**ITB #2025-018906**

## **HOVLAND HALL WEST WING REMODEL CONSTRUCTION SERVICES**

### **ADDENDUM NO. 1**

OSU Hovland Dry Lab Remodel

A-050

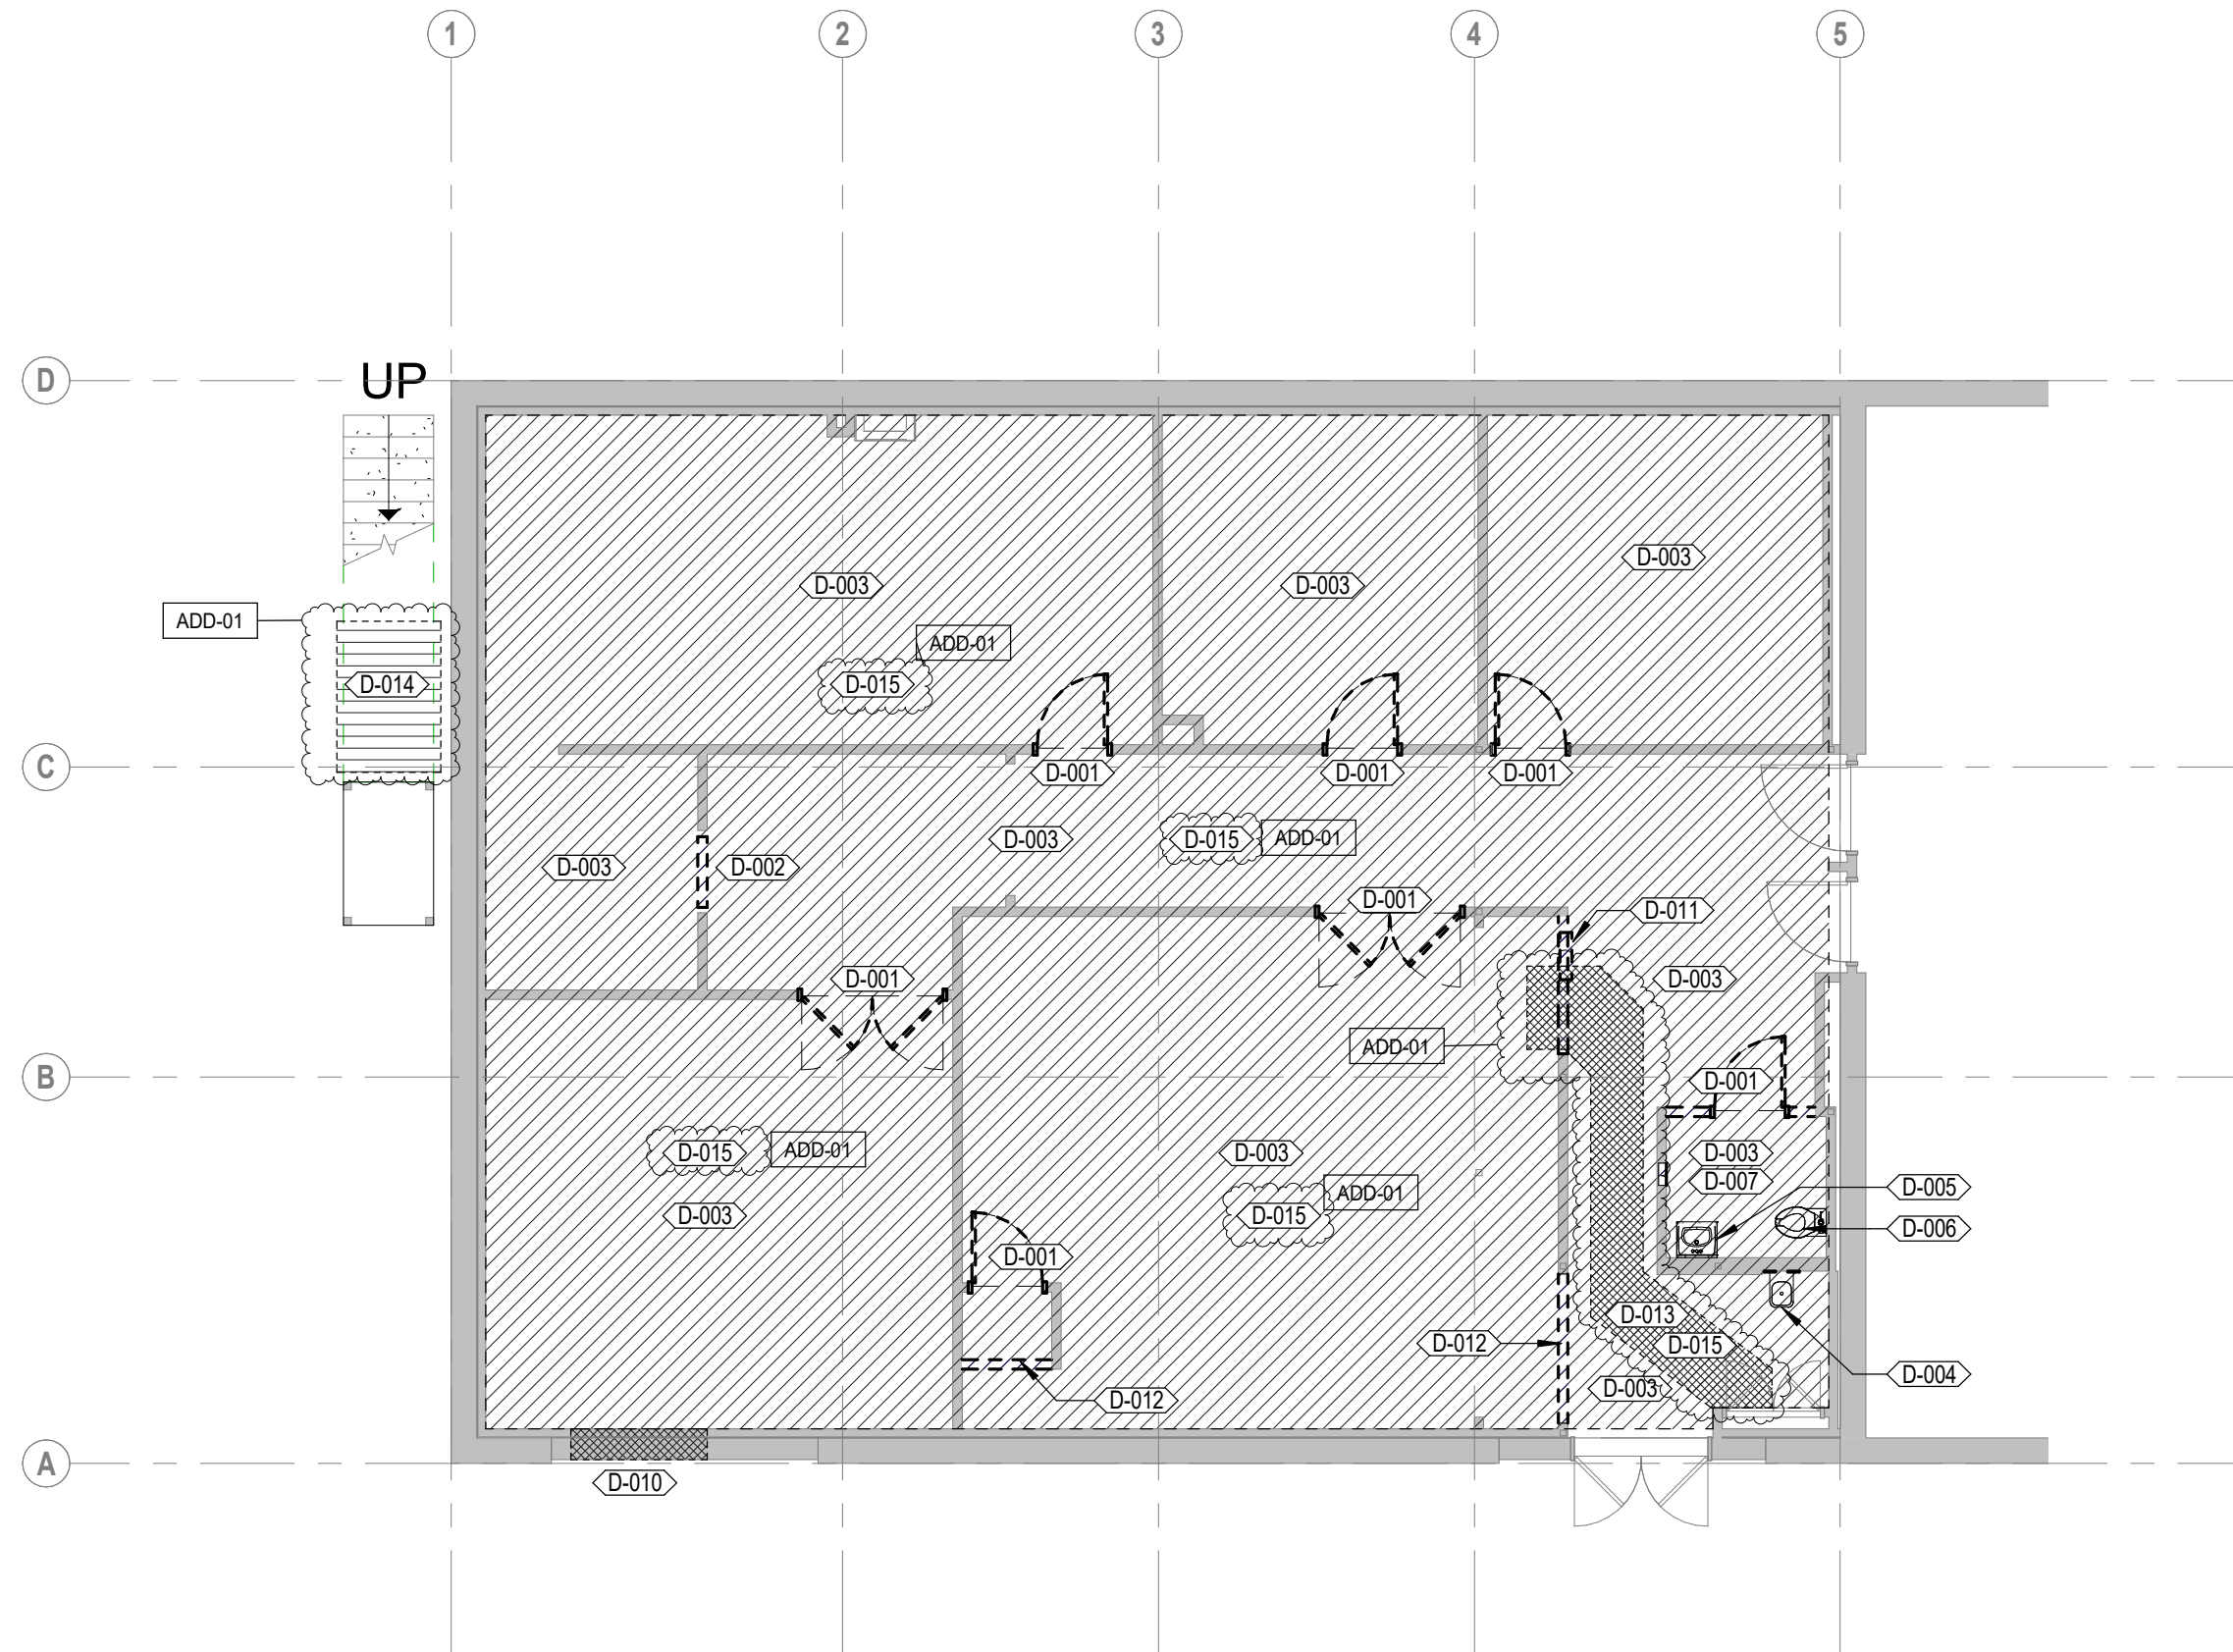
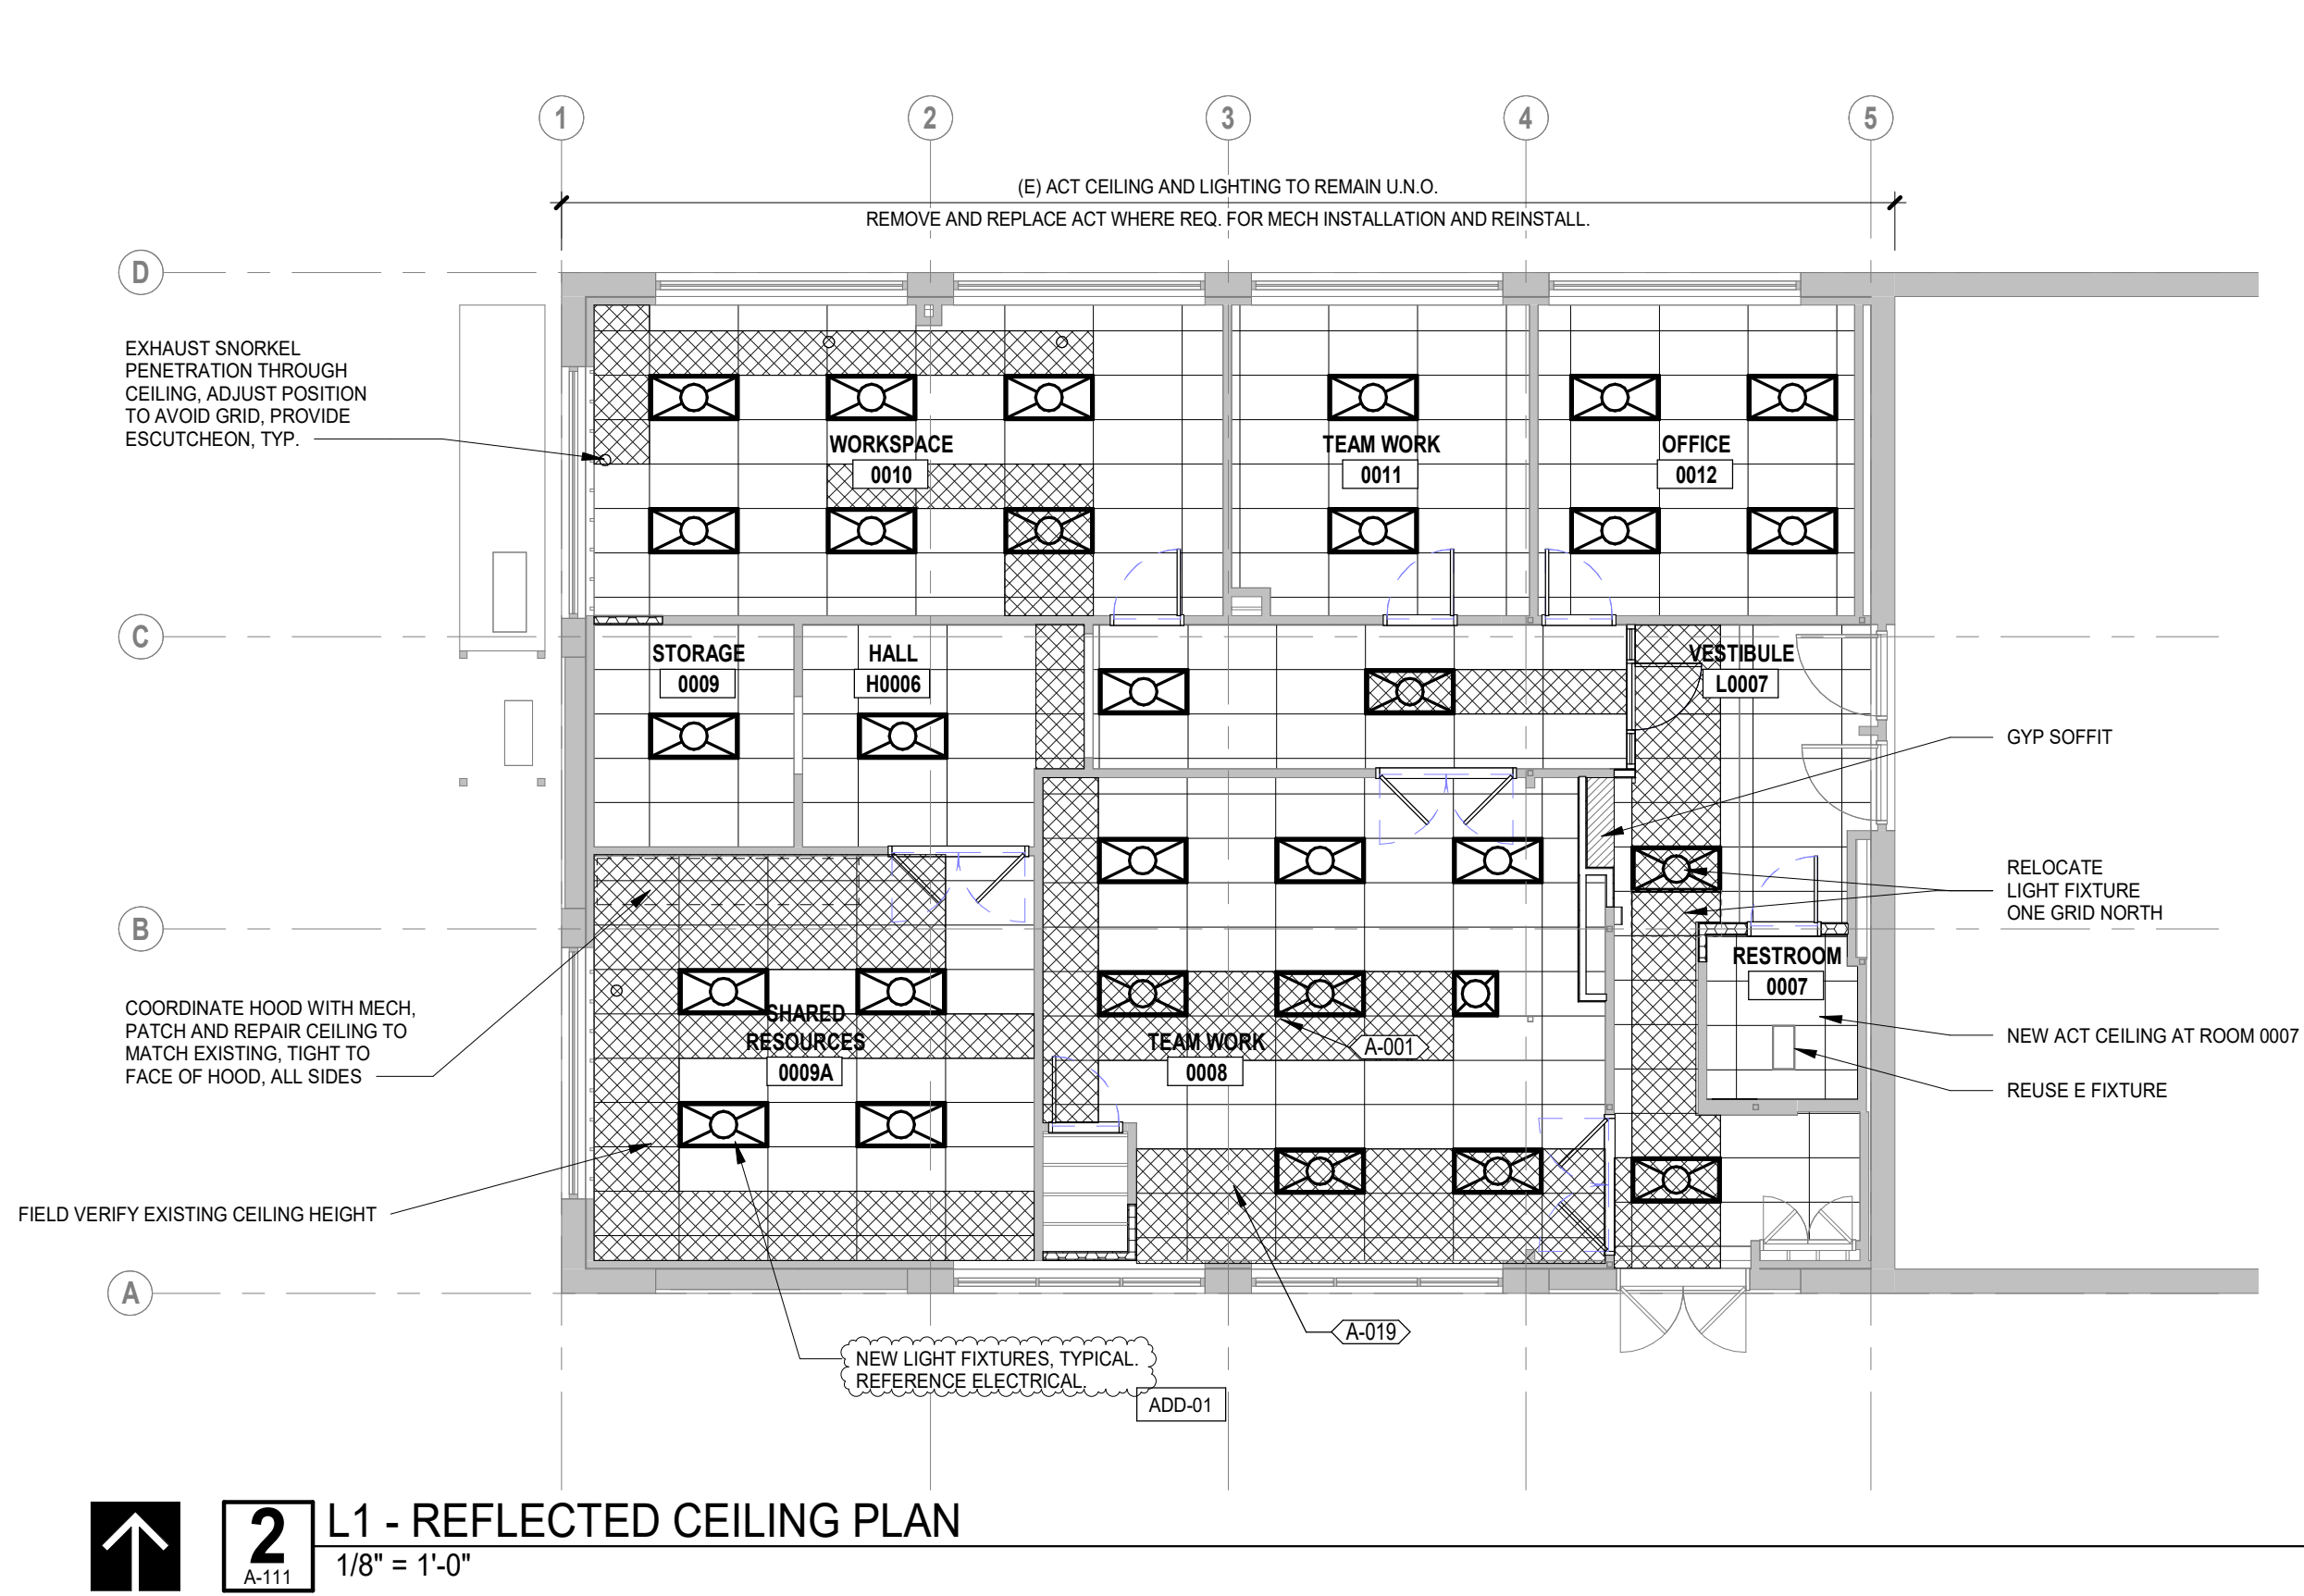
- 1) Sheet A-050 (re-issued, attached). Revisions include:
  - a) Demolition plan revised as shown.
  - b) Keynotes revised as shown.
- 2) Sheet A-111 (re-issued, attached). Revisions include:
  - a) Floor Plan revised as shown.
  - b) Reflected Ceiling Plan Revised as shown.
  - c) Floor Levelling + Concrete Pourback Plan revised as shown.
  - d) Keynotes revised as shown.
- 3) Sheet A-301 (re-issued, attached). Revisions include:
  - a) Detail # 2 revised as shown.
- 4) Sheet A-501 (re-issued, attached). Revisions include:
  - a) Door schedule and notes revised as shown.
- 5) Sheet A-601 (re-issued, attached). Revisions include:
  - a) Elevation 1 revised as shown.
  - b) Keynotes revised as shown.
- 6) Sheet A-602 (re-issued, attached). Revisions include:
  - a) Elevations 2-6 revised as shown.
  - b) Enlarged Plan revised as shown.
